NOTICE OF DECISION
Velkommen Apartments
TUM-22-0213
May 6, 2024

RE: TUM-22-0213 Velkommen Apartments – Formal Site Plan Review Approval
7125 Littlerock Road SW, Tumwater, WA 98512, Parcel # 12704430500
Construction of a 16-unit apartment complex

March 7, 2024, the Development Review Committee for the City of Tumwater reviewed your Formal Site Plan Review application for the above-referenced project. The City hereby approves the application subject to the conditions outlined below:

SITE PLAN

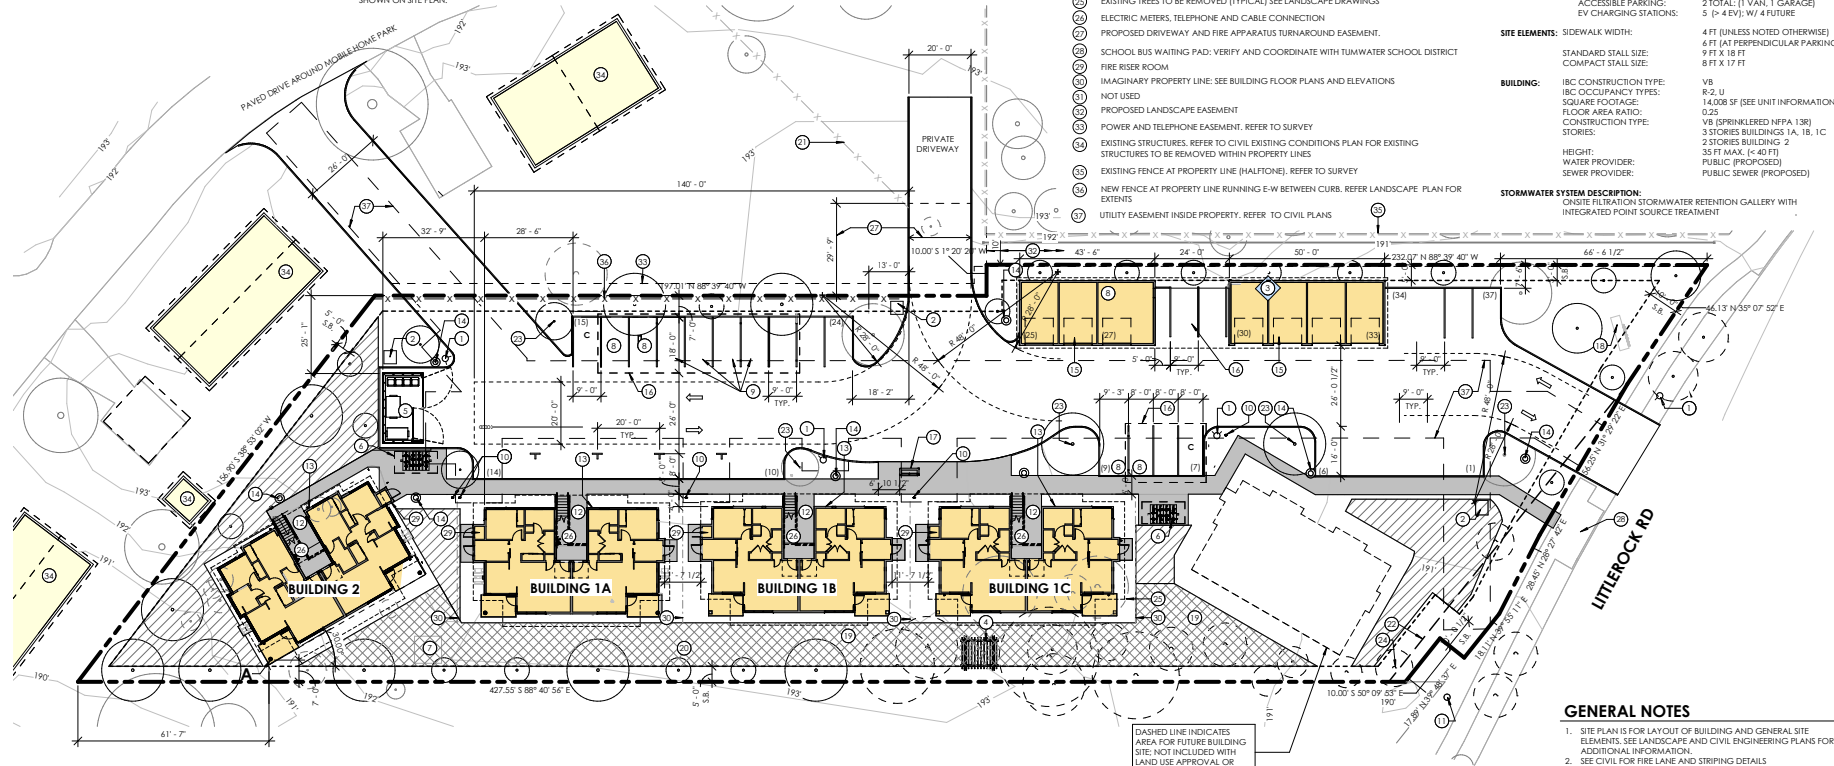
The site plan meets the standards of TMC 18.42.130.

The site plan meets this standard.

The site plan meets this standard.

The site plan shows appropriate building setbacks. Details for mechanical equipment meeting setback requirements shall be included in building permit submittal.

The site plan meets this standard.

Site planning measures appear to be met. A narrative describing how the development meets the building design standards of the Citywide Design Guidelines shall be included with building permit submittal.

The site plan appears to meet minimum parking requirements. Long term bicycle storage is proposed to be located within each unit. Architectural plans shall show designated bicycle storage in each unit as part of building permit submittal.

The site plan shows a monument sign at the location of the stormwater facility and over the front yard setback line. If the sign is located within the 10 foot front setback, it is limited to 42 inches.
